ADDENDUM

TO A FLOOD RISK ASSESSMENT

SITE SOUTH OF HIGH STREET ASCOT, SL5 7JE

REPORT REF: 21146-REP03-FRA ADDENDUM 1

Figure 14 Drainage strategy, Catchment zones and discreet discharge via ECO-90 clusters as submitted in FRA Addendum Revision P3

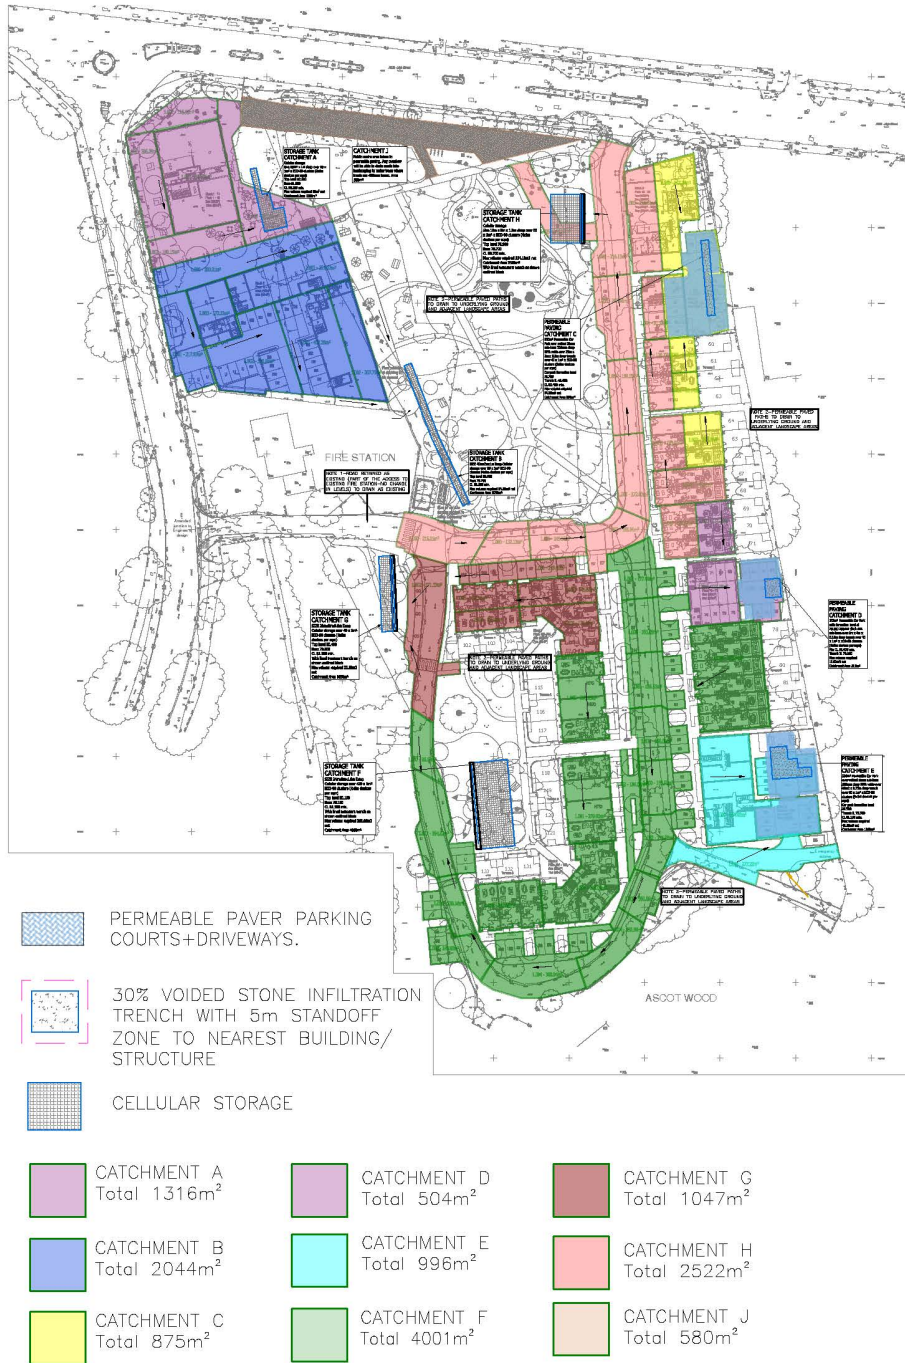
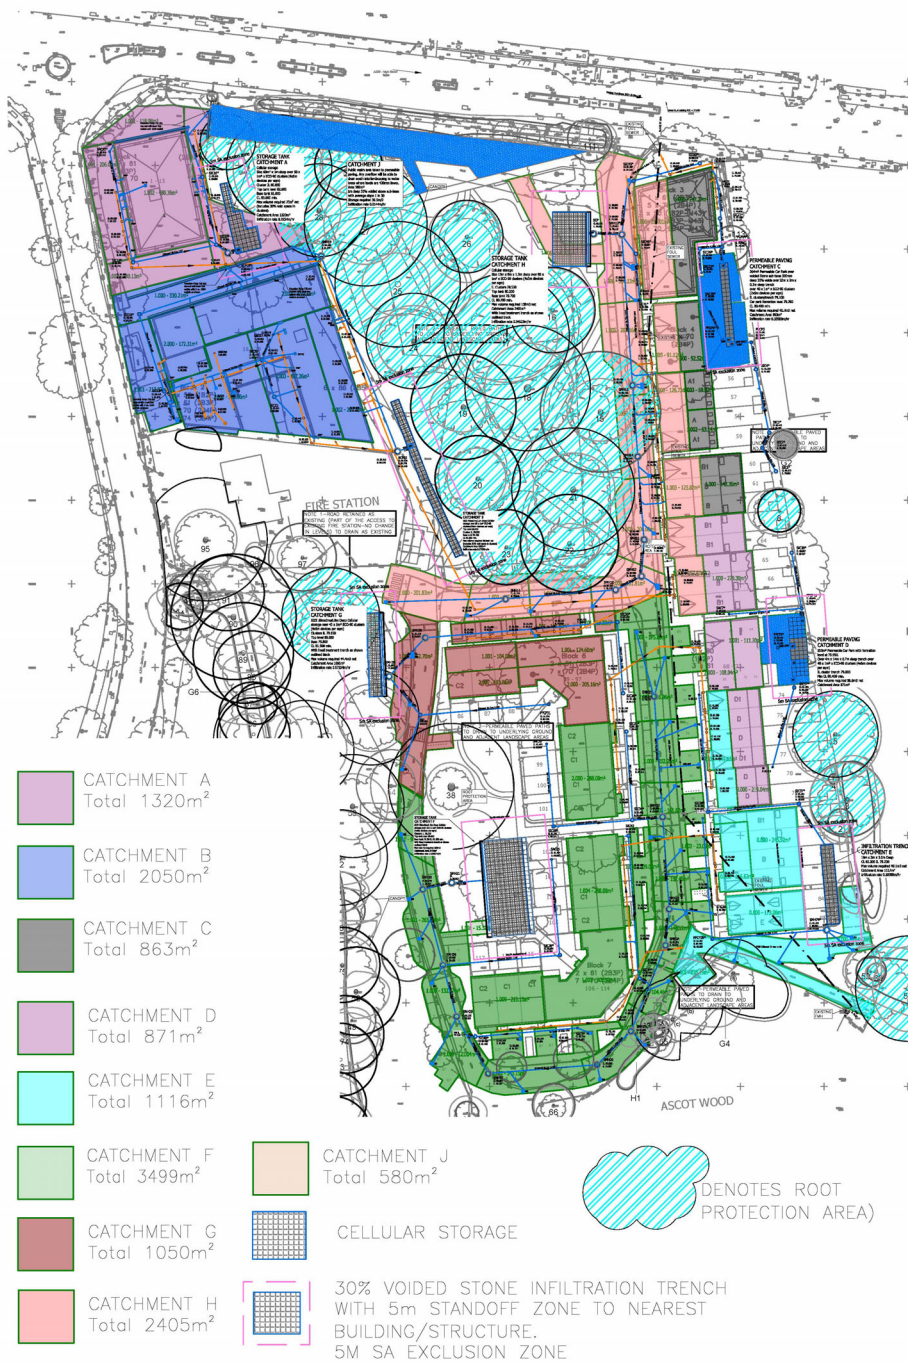
How is this infiltration rate arrived at from the cluster calculation on the previous sheet and from the in situ testing undertaken by Groundwater Dynamics?

Calculations for the infiltration rates take the results of the test drilling exercise and apply a modified version of the BRE365 calculation (modified for shape of trial and volume of water) by following the BRE calculation alongside the calculations in the report - and taking notice of the units, the calculation procedure is clear.
